Overview

Staff's Role

Drawdown Analysis

Figure 6. Cooper-Jacob Analysis for the Big Gulch Stock Well with Water-Level Trend Corrections

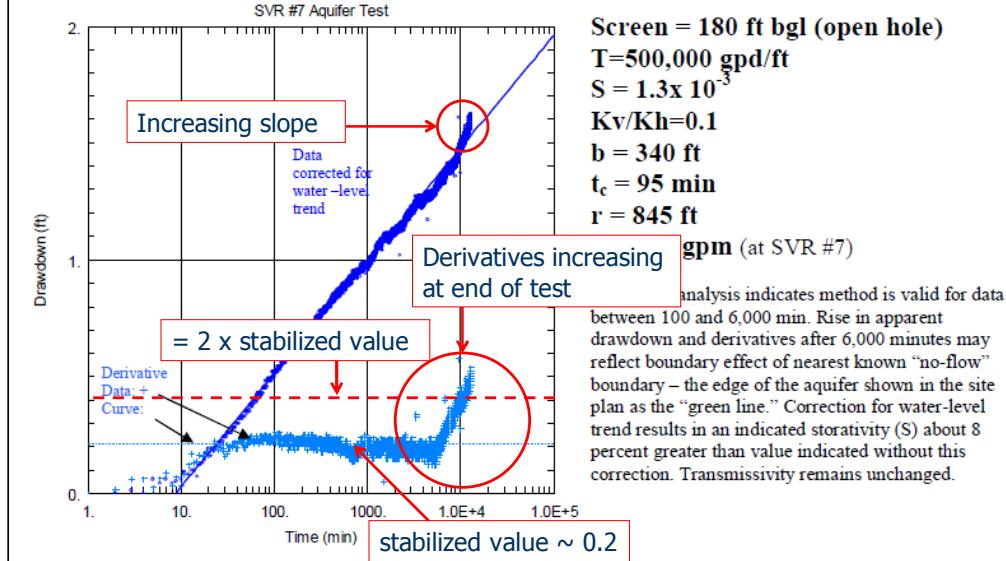
Let me show you what I'm talking about. This is Figure 6 from Exhibit 45. It's a plot of trend-corrected drawdown versus the logarithm of time in the monitoring well closest to the test well. The increase in the slope of the data trend that I've identified with the upper red circle is diagnostic of the cone of depression encountering a negative hydraulic boundary, as is the increase in the value of the derivatives, which I've identified with the lower red circle. All external influences have already been removed from these data so there doesn't appear to be a more plausible explanation. The drawdown plot clearly shows that the aquifer test ended while the slope of the data was still changing and, equivalently, the value of the derivative was still increasing. Ending the test while those things are occurring is contrary to the goal of establishing boundary conditions in order to assess long-term performance of the aquifer. The fact that the derivative values have increased by more than a factor of two is cause for concern to staff because, although inconclusive, it suggests that the drawdown data possibly were being affected by more than one hydraulic boundary.

EXHIBIT 44

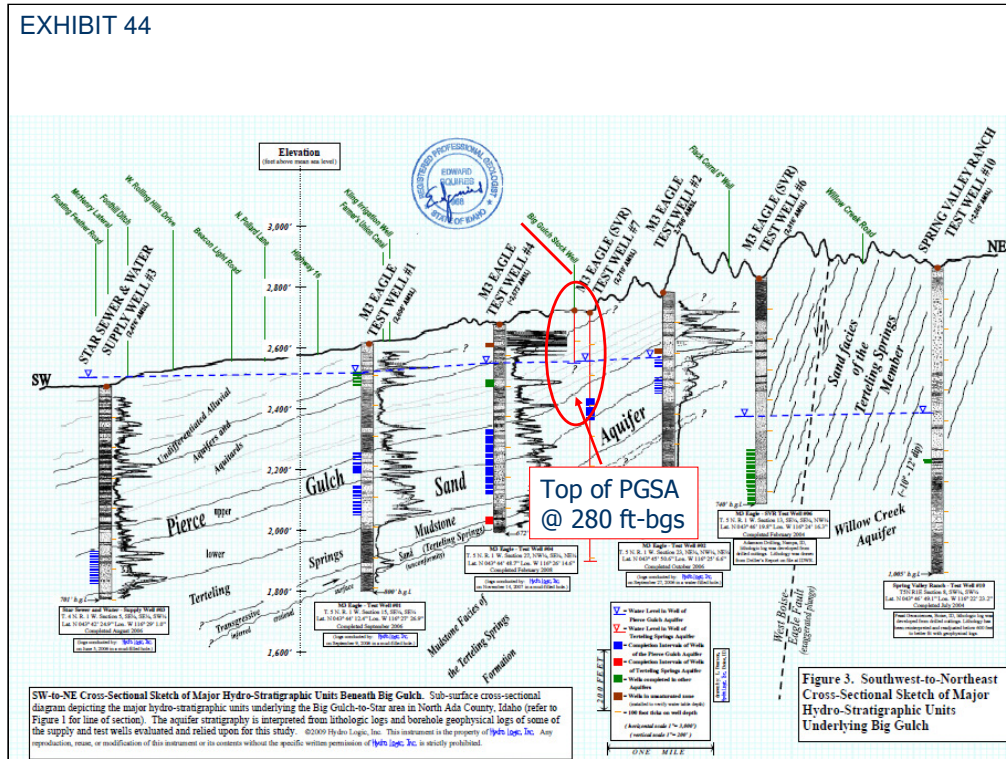
Here is Figure 3 from the same report. The PGSA beneath the Big Gulch test well on this cross-section is shown at a depth of 280 feet, which agrees with the reference in the text to there being a 100-foot difference between the total depth of the well and the top of the aquifer, which I've identified with a red arrow on the cross-section.

Figure 5. Geologic Cross-Section through the M3 Eagle Site

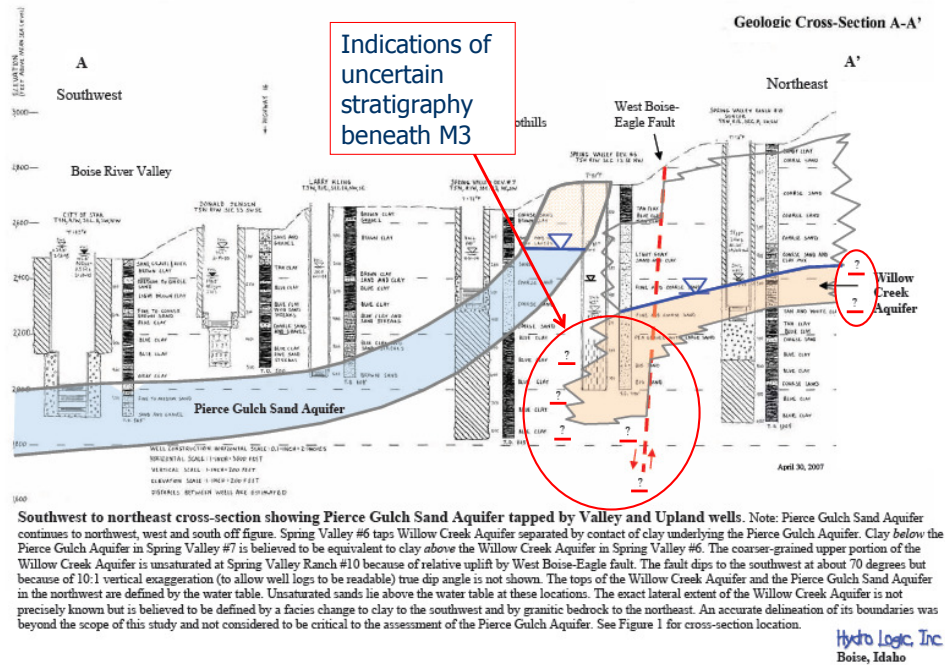
This geologic cross-section is Figure 5 from the Year 1 Progress Report, Exhibit 2. The section runs from the southwest to the northeast through Big Gulch on M3 property. Question marks are used between SVR#7 and SVR#6 to indicate uncertainty in the stratigraphic relationships between these wells, both of which occur on the same side of the West Boise-Eagle Fault. That indication of uncertainty suggests that the stratigraphy beneath M3 is complex.

Figure 5. Geologic Cross-Section through the M3 Eagle Site

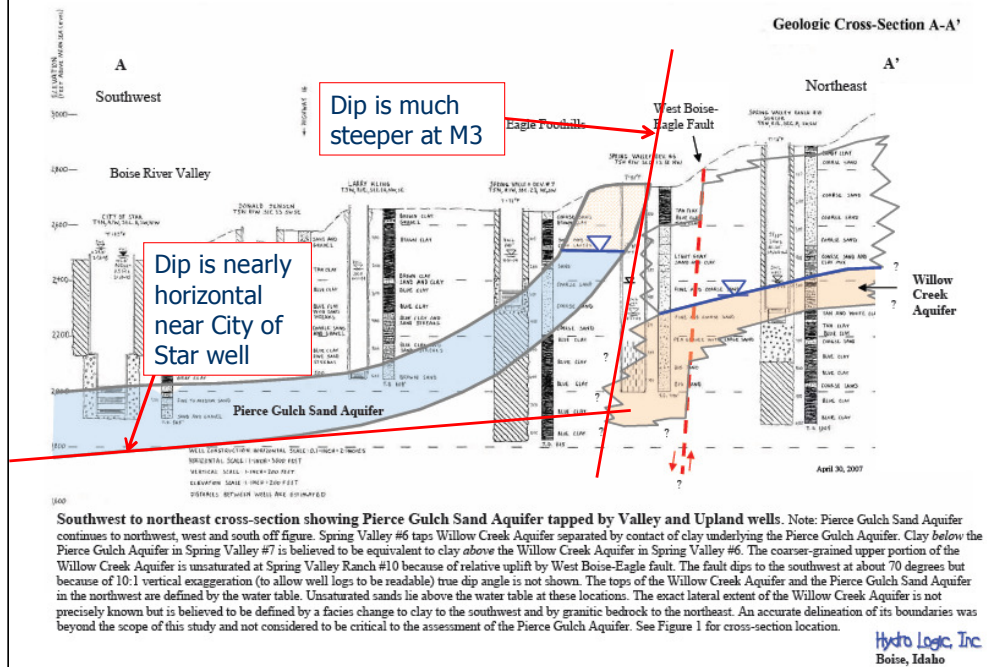
Also notice this depiction of the PGSA from Exhibit 2 as having concave upward top and bottom structures with a continuously increasing dip as you move further to the northeast, which is to the right on this diagram. I've added red lines to show how the dip of the contact between the PGSA and the underlying Terteling Springs Formation dramatically increases as you move further along section and away from the center of the basin. The nearly horizontal red line represents the dip of the contact near the City of Star well and the much steeper solid red line illustrates that the dip is thought to be much steeper near the intersection of the PGSA with land surface. As far as I know, this stratigraphic complexity is not discussed in the supporting documentation.

EXHIBIT 44

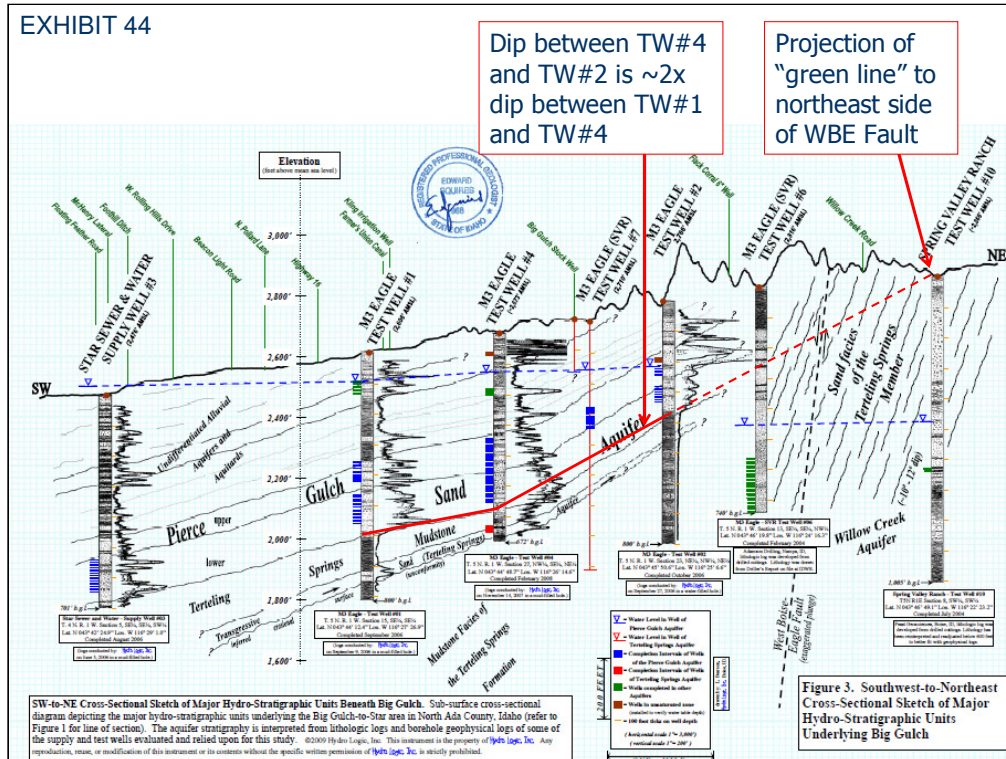
Notice now that the finalized version of this same section, Figure 3 from Exhibit 44, shows a somewhat different but also difficult to explain interpretation in which the dip of the PGSA bottom structure between TW#4 and TW#2 is more than double the slope of the bottom structure between TW#1 and TW#4. Note that the projection of the contact between the PGSA and the underlying mudstone using the steeper dip would cause the so-called green line to be located well to northeast side of SVR#6. In fact, the projection of the contact, which I've drawn on the figure using a dashed red line, intersects land surface near SVR#10, which is northeast of the West-Boise Eagle Fault.

EXHIBIT 44

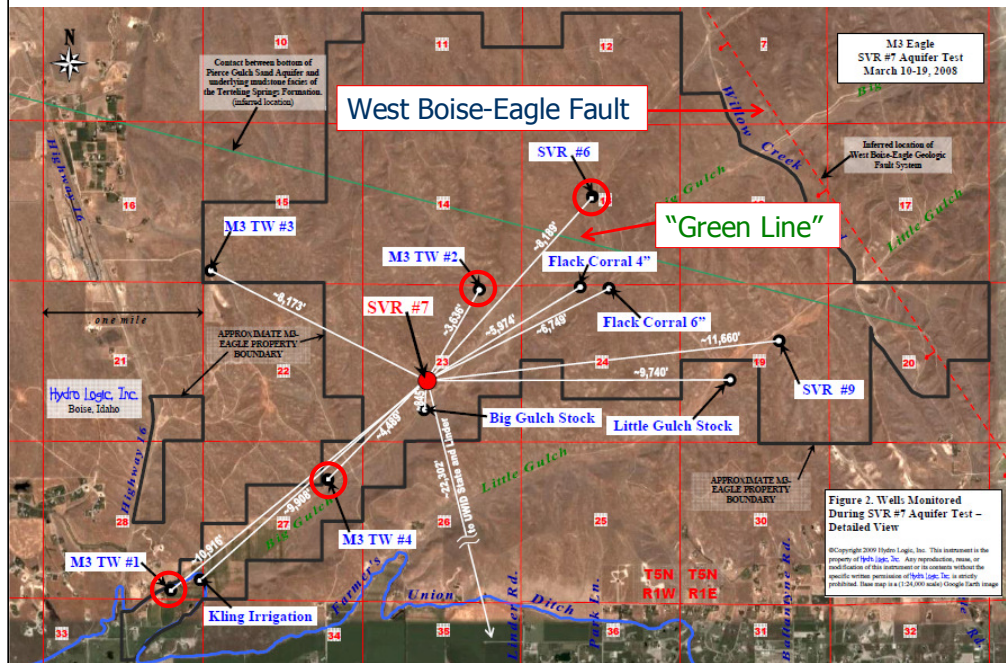
However, this is contrary to the inferred location shown on Figure 2 in Exhibit 44, the SVR#7 Aquifer Test Report. The green line is instead shown on the southwest side of the West Boise-Eagle fault which would require an even steeper dip between TW#2 and SVR#6 than the already increased dip that was shown on the last slide. A slight steepening might be expected as you move closer to the sediment source but the increase in dip necessary to keep the green line on the west side of SVR#6 is dramatically greater and, as I mentioned, the geologic mechanism that would cause this to occur is not explained in the supporting documentation.

Figure 5. Geologic Cross-Section through the M3 Eagle Site

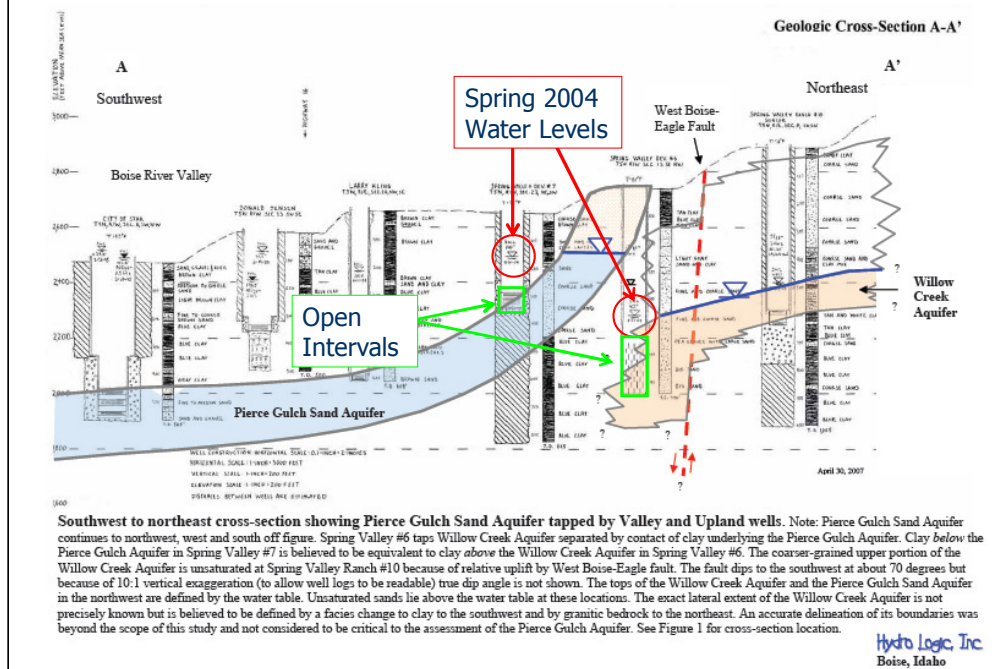
I'd like now to go back to Figure 5 in Exhibit 2, which is the Year 1 Progress Report. Notice that this figure shows an abrupt water level change between SVR#7 and SVR#6 – the water level in the shallower SVR#7 well is roughly 200' higher than in the well with a deeper completion interval, SVR#6. The fact that this significant water level difference appears to occur on the same side of the known West-Boise Eagle fault also is contrary to our expectations based on the information that we've been provided. A much lower water level in the deeper well might be expected on opposite sides of a no-flow barrier but it is not expected between wells on the same side of a fault, especially in an area where, as Mr. Squires testified, there is supposed to be an upward hydraulic gradient. The cause for the dramatic change in dip and apparent strong downward hydraulic gradient are not explained in the HLI submittals and suggests to staff that the hydrostratigraphy beneath the M3 property is complex. I should also point out that the pronounced downward vertical gradient is not explained by the so-called green line because the aquifer underlying the PGSA is laterally continuous in the southwest direction according to the conceptualization shown on this figure. Based on my experience characterizing and modeling faulted, fluvial-deltaic aquifers in Texas, a plausible explanation for what's going on between SVR#7 and SVR#6 is that the stratigraphic section is cut by an unidentified fault, which most likely parallels the West Boise Eagle fault. This possibility could dramatically change the significance of the so-called green line on the hydrogeology beneath M3.

EXHIBIT 45

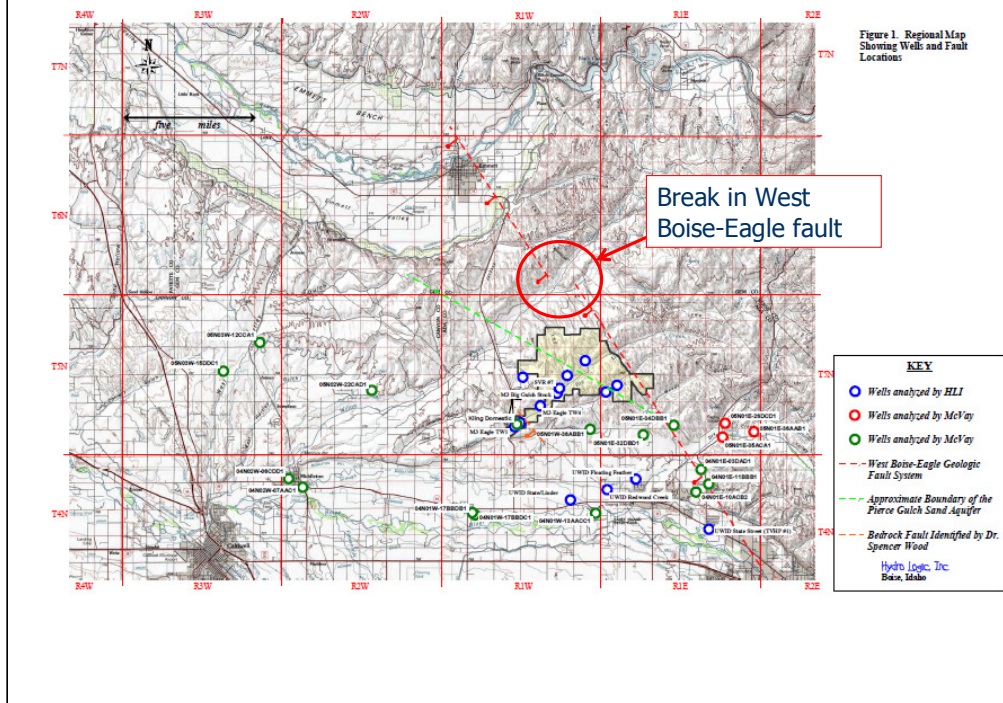
Additional complexity is revealed by looking at Figure 1 from the Response to our Staff Memorandum, Exhibit 45. There is a break in the West-Boise Eagle Geologic Fault north of M3 in the area that I've circled in red. I'm not sure whether the offset was caused by a transverse fault or some other mechanism but, whatever the cause, the nonlinearity of this feature complicates the hydrogeology of the PGSA since it transects both the shallow and deep strata.

EXHIBIT 45

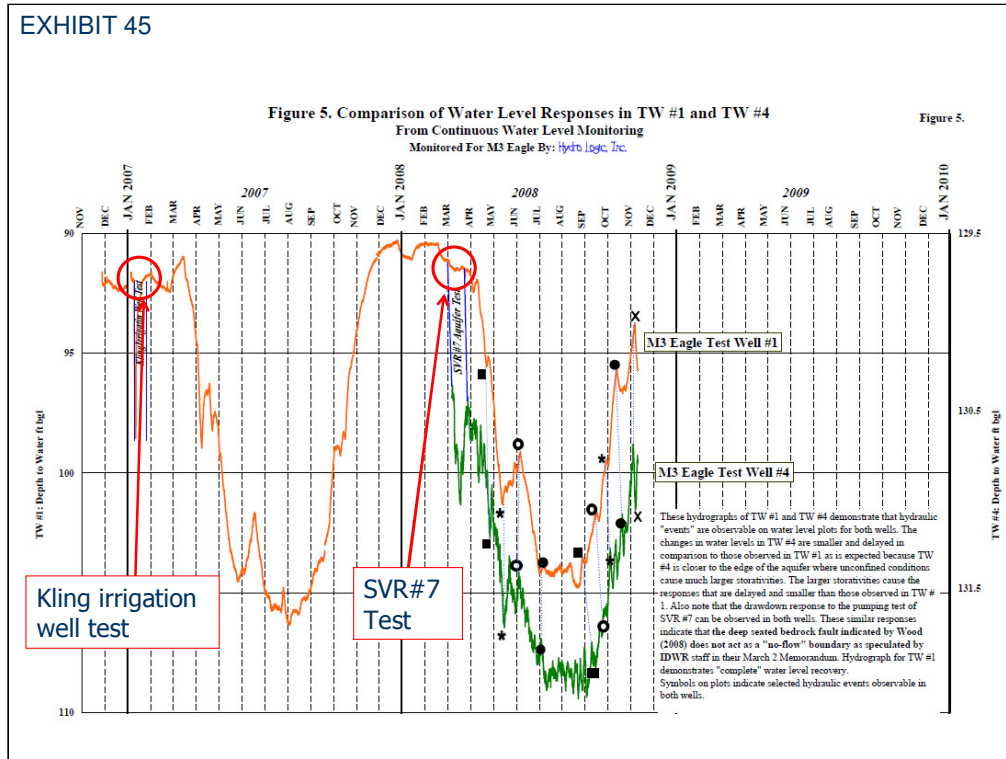
Here is Figure 5 from HLI's Response to the Staff Memorandum. The labeling by HLI indicates that the water levels in TW#1 are the orange data and that the water levels in TW#4 are the green data. I've identified the water levels in TW#1 during the Kling Irrigation and SVR#7 tests by drawing red circles around those data. Note that the maximum water level change is such a small fraction of 1 foot that it's almost imperceptible during both the Kling irrigation and SVR#7 aquifer tests. It's therefore difficult to determine based on looking at this figure whether or not there was any drawdown in TW#1 during either test. Further complicating interpretation of this figure is the fact that TW#1 is a nested piezometer, which monitors water levels at 5 different elevations. According to Table 1 in Exhibit 44, which is the SVR#7 aquifer test report, none of the five zones responded to pumping during the SVR#7 test. And according to page 200 of Exhibit 12, the shallowest piezometer, Zone 5, "*did not react at all to pumping*". The text on page 205 from the same report indicates that the minimum end-of-test drawdown among the other four TW#1 piezometers was 6.5 ft in Zone 1. Because Figure 5 from the Response to the Staff Memorandum indicates almost imperceptible drawdown during the Kling irrigation test and the smallest drawdown in any of the four zones that did respond to pumping was 6.5 ft, the only logical interpretation is that the orange line represents the water levels in Zone 5 of TW1, which like the Kling domestic well, is identified by HLI as being completed in the shallow alluvial aquifer system. It's difficult to reconcile HLI's conclusion that the water level in TW#1 recovered within two weeks with indications that the water level in Zone 5 did not respond to pumping in either of M3's aquifer tests. The indication from the aquifer test reports is that there was no water level decline from which to recover.

Figure C-3. Actual and BE-Corrected Water Levels for Big Gulch Stock Well

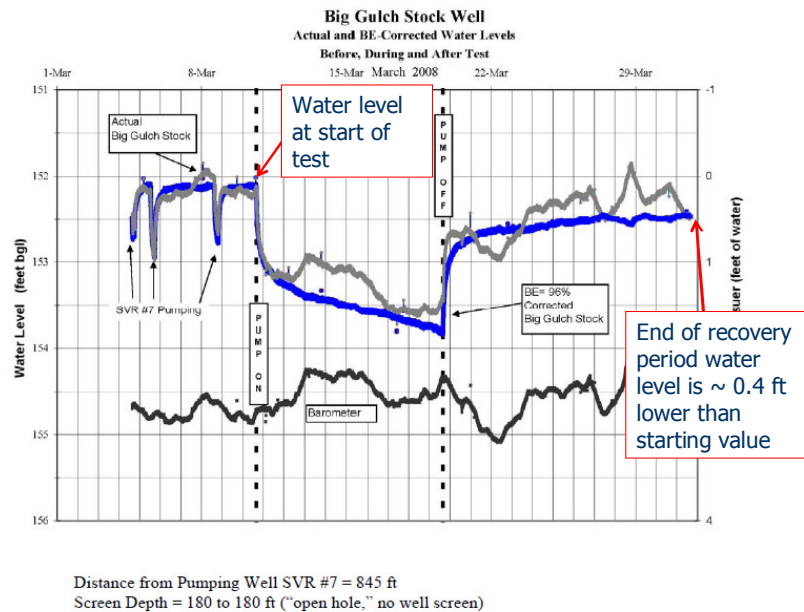
I want to focus now on the SVR#7 aquifer test. This hydrograph is Figure C-3 from Exhibit 44, which is the SVR#7 Aquifer Test Report. It's an arithmetic plot of water level versus time. The blue colored data are the water levels after correcting for barometric pressure fluctuations. The period of monitoring encompasses the period of pumping and water level recovery. You can see that the water levels decline quickly in response to the onset of pumping on March 10, 2008 and they partially recover in response to the pump being shut off on March 19. In our Staff Memorandum, we expressed concern with the fact the water levels in the Big Gulch Stock well, which again was the closest monitoring well to the SVR#7 test well, and the only observation well to have more than 1-foot of drawdown during the 9-day test, did not appear to be trending toward full recovery. Note that the water level at the end of the water level recovery period, twelve days after the pump was shut off, was approximately four tenths of a foot lower than the water level that was measured immediately prior to turning on the pump. Incomplete or delayed water level recovery are concerns to staff because they can be indications that the aquifer is of limited extent.

Figure 26. Theis Recovery Analysis for the Big Gulch Stock Well with no Water-Level Trend Correction

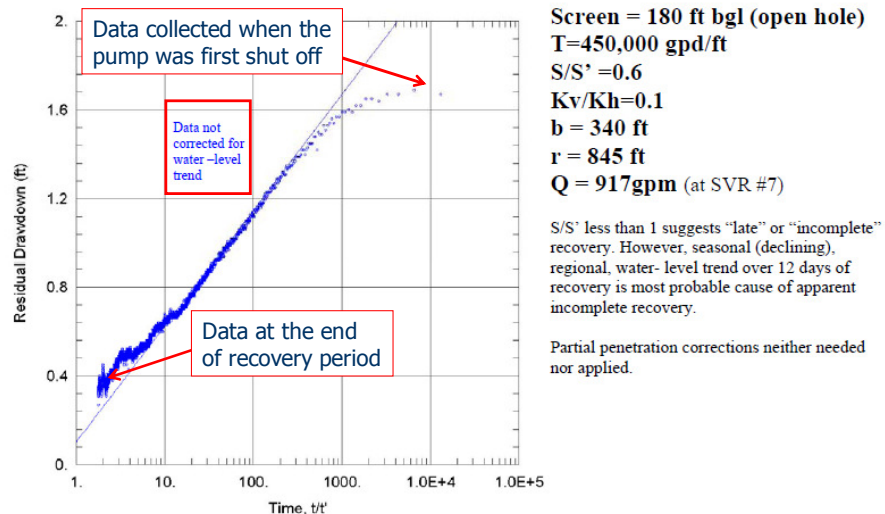
This is Figure 26 from Exhibit 44, the SVR#7 Aquifer Test Report. The water level recovery data from the previous figure have now been plotted in the standard format for quantitative analysis, which is as residual drawdown, the difference between the original pre-test water level and the water level during recovery, versus the logarithm of the ratio t , the time since pump was turned on, divided by t' , the time since the pump was turned off. Note that the data on this plot have not yet been corrected for the regional water level trend. The main thing I want to point out about this plot is that the first data to be collected after the pump shut off are the blue colored dots in the upper right hand part of the plot and the data in the lower hand portion of the plot are the last recovery data that were collected so the recovery time increases to the left. Also note that the ending residual drawdown values are approximately four-tenths of a foot which means the water levels at the end of the recovery period are four-tenths of a foot lower than the pre-pumping level. That's the same determination that I made for the previous slide because these are the same water level data - they've just been plotted differently to facilitate analysis.

Figure 27. Theis Recovery Analysis for the Big Gulch Stock Well with Water-Level Trend Corrections

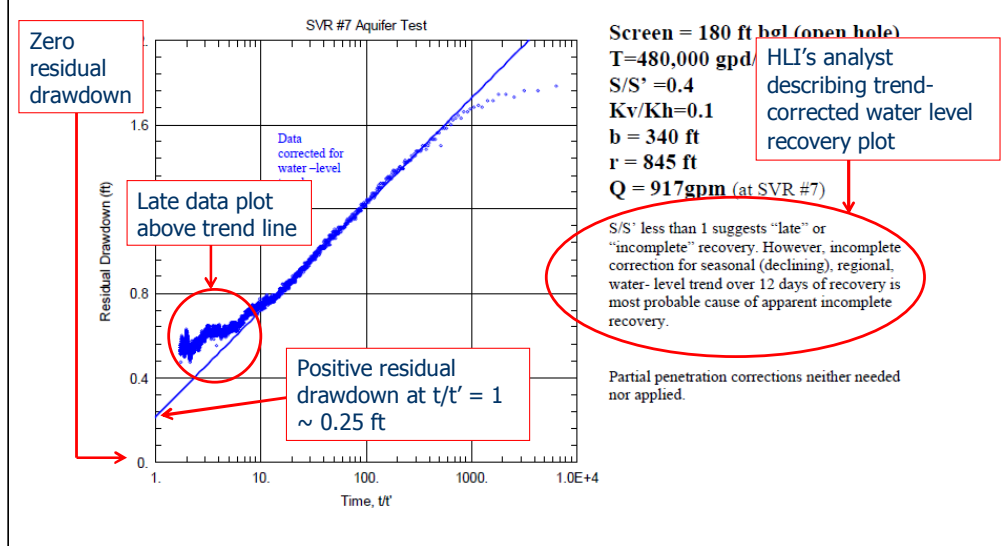
This is Figure 27 from Exhibit 44, the SVR#7 aquifer test analysis report. This plot is of the same data one more time, only now they have been corrected for the water level trend. Our review of this diagram was the basis for our comment about the apparent failure to achieve water level recovery in the Big Gulch Stock well. That conclusion was based not only on the ending residual drawdown values, which are slightly more than half of a foot on this diagram, but the fact that the data trend is not toward zero residual drawdown but instead is toward a positive residual drawdown of approximately one-quarter of a foot. The positive, non-zero intercept is diagnostic of an aquifer of limited extent and that is a major concern for staff in the context of evaluating the sustainability of the resource. HLI's analyst acknowledged the possibility of late and/or incomplete recovery in the caption on the right side of the figure. It says "*S/S' less than 1 suggests late or incomplete recovery. However, incomplete correction for seasonal, declining, regional water-level trend over 12 days of recovery is most probable cause of apparent incomplete recovery.*"
